EARTHBOUND SYSTEM LOCATION LAYOUT SHEET

| SHEET TITLE: | EARTHBOUND SEISMIC HOLDOWN SYSTEM LOCATION LAYOUT DRAWINGS. IAPMO ER-0429 |

SHOP DRAWING / SUBMITTAL REVIEW

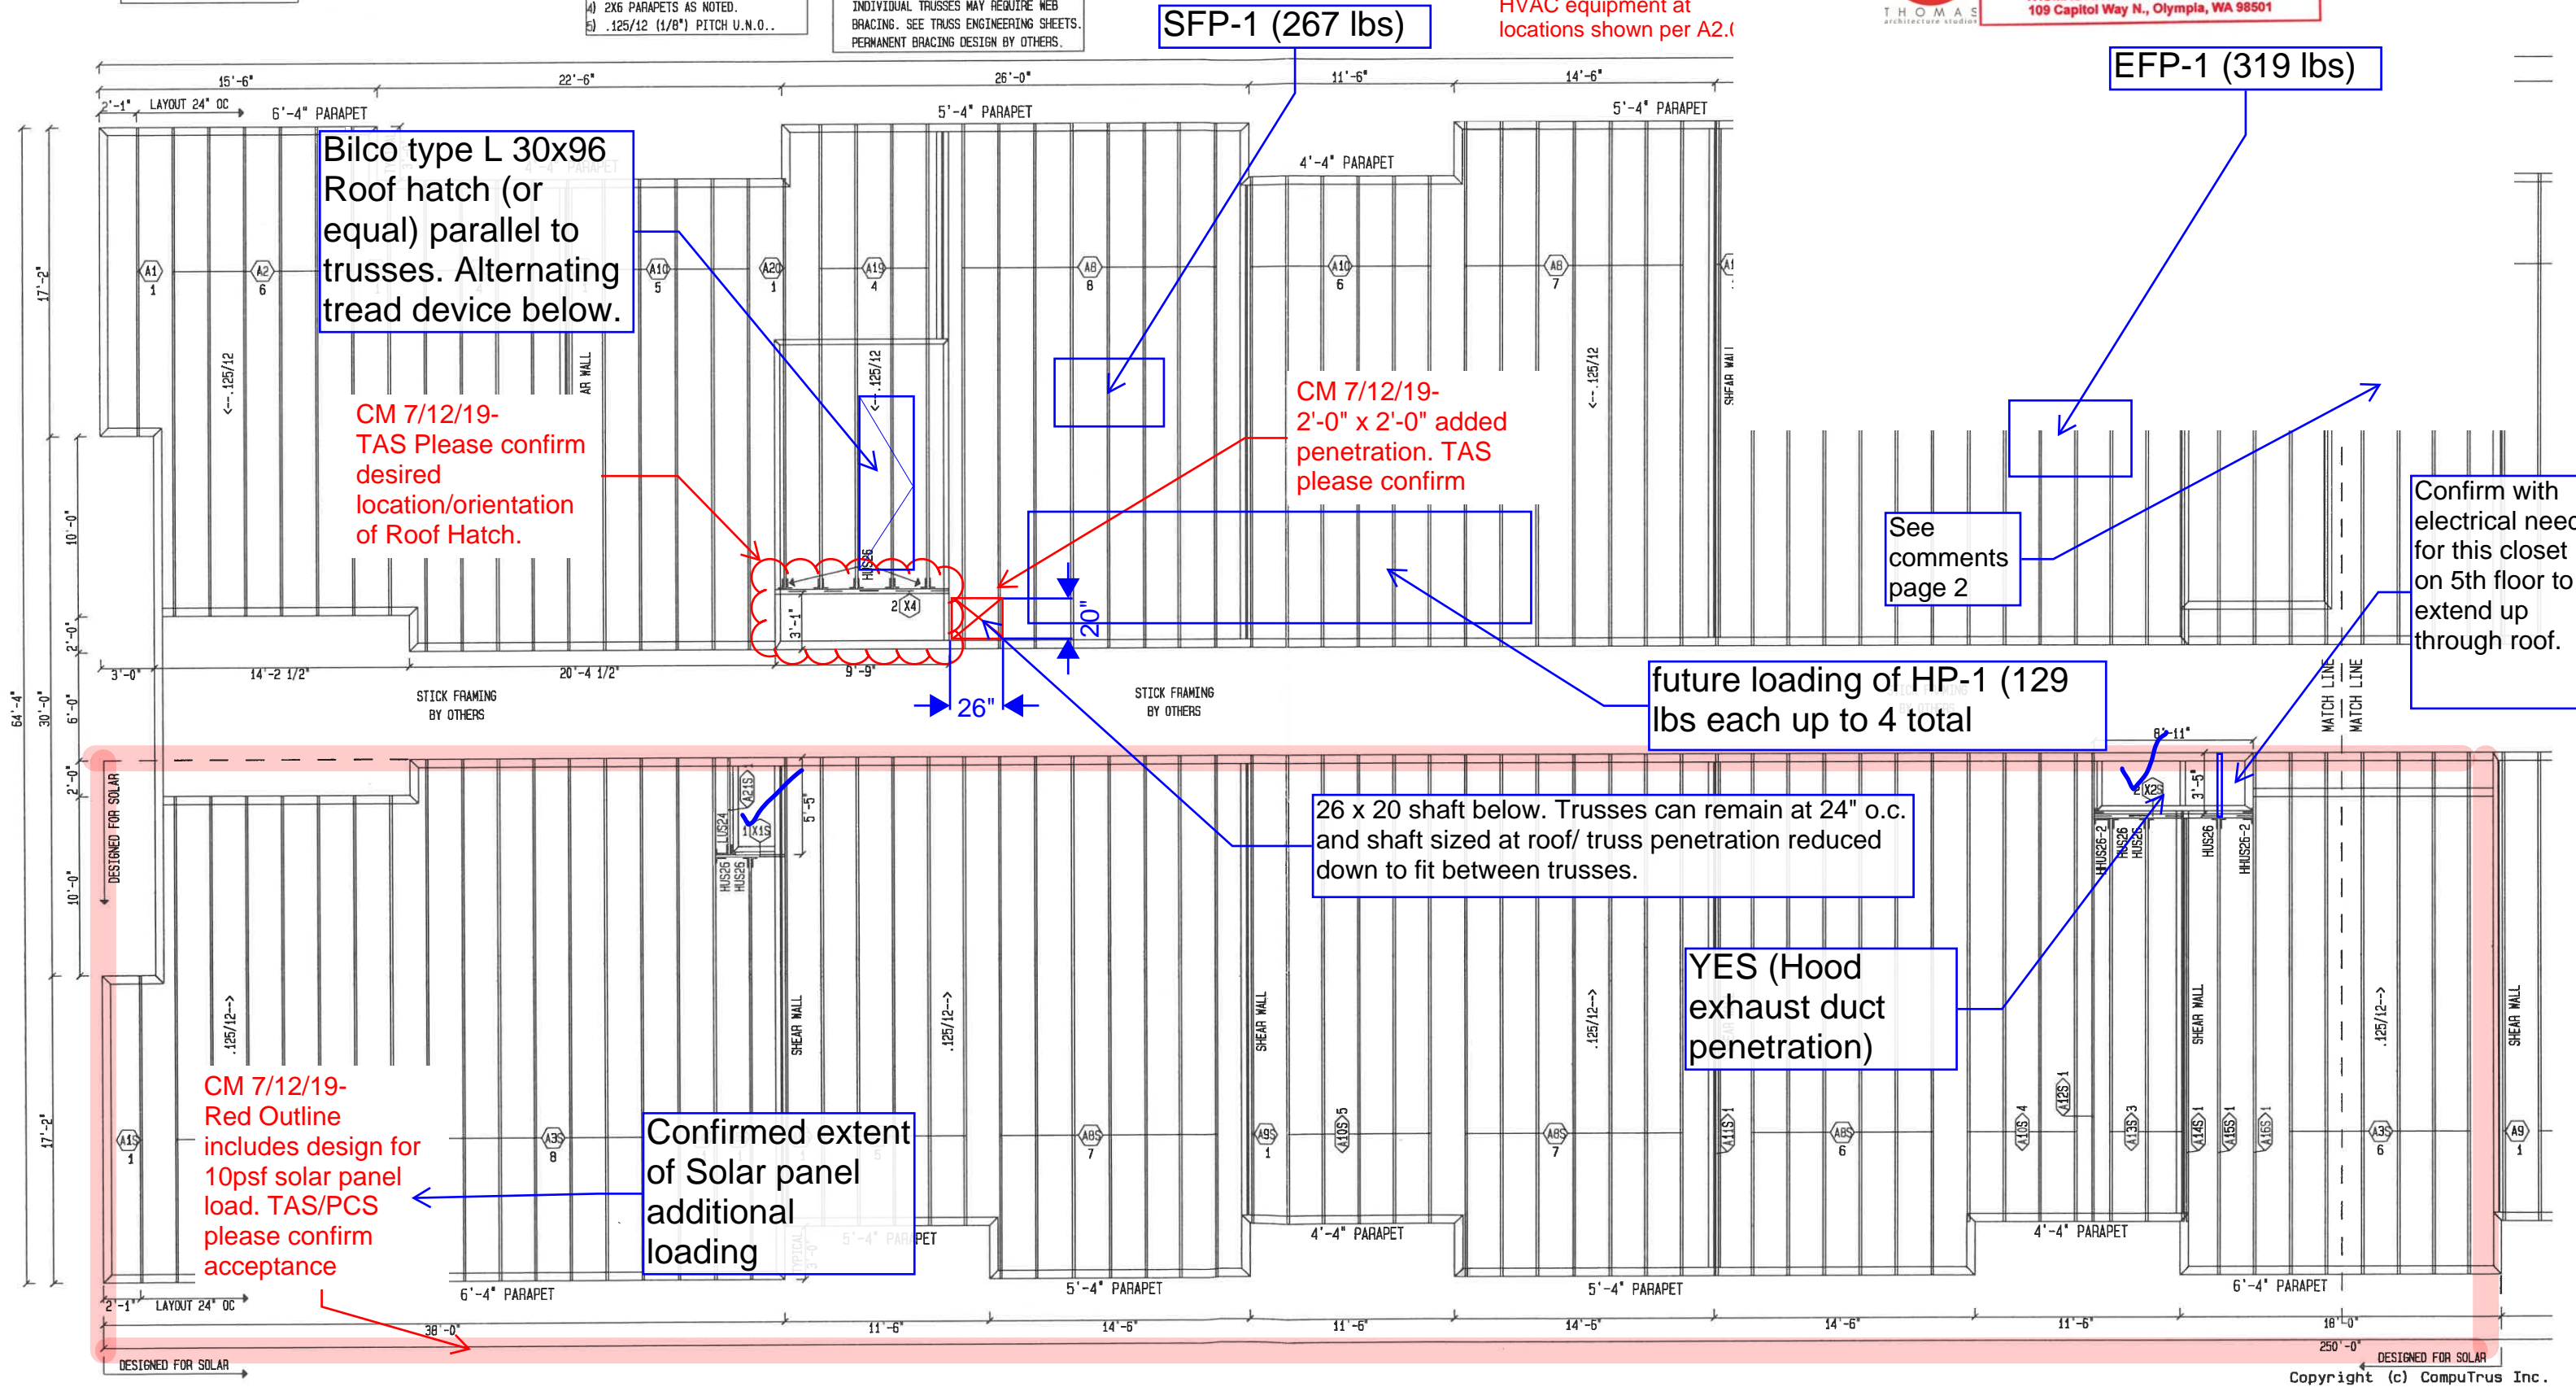
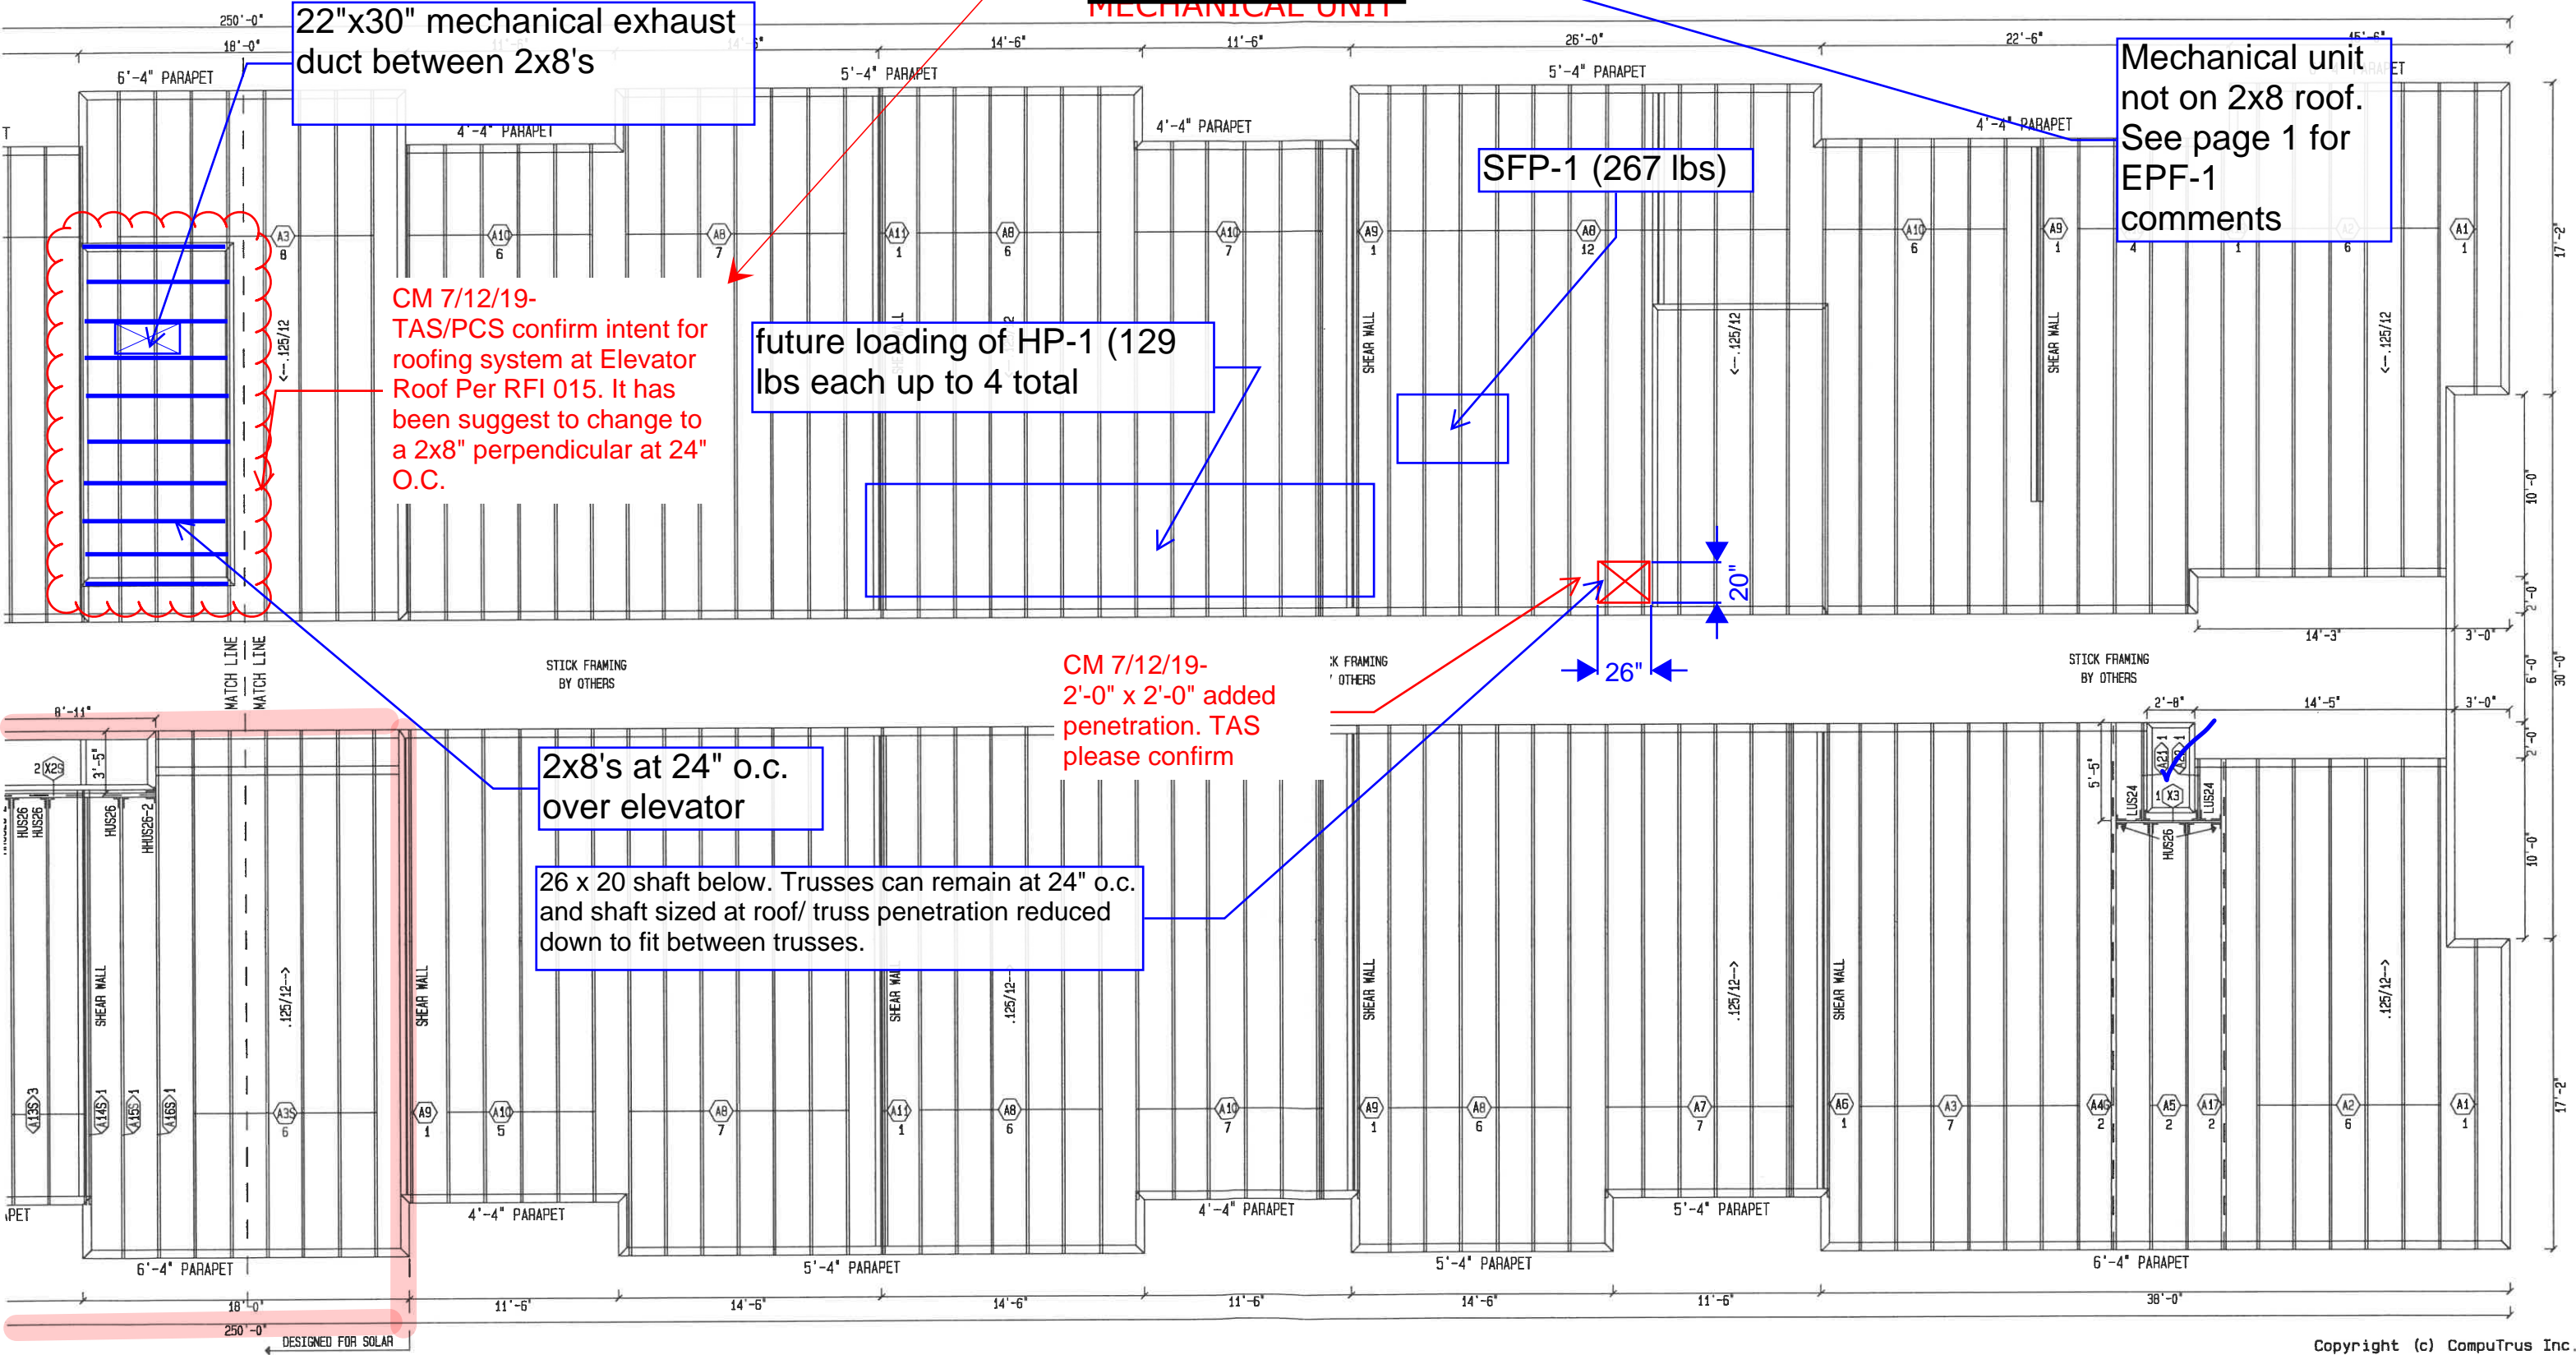
CM 7/12/19-TAS/PCS confirm intent for roofing system at Elevator Roof Per RFI 015. It has been suggest to change to a 2x8" perpendicular at 24" O.C.

CM 7/12/19-2'-0" x 2'-0" added penetration. TAS please confirm

CONFIRMED - 2X8 FRAMING @ 24" O.C. PROVIDE DOUBLE 2X8'S AROUND THE MECHANICAL UNIT
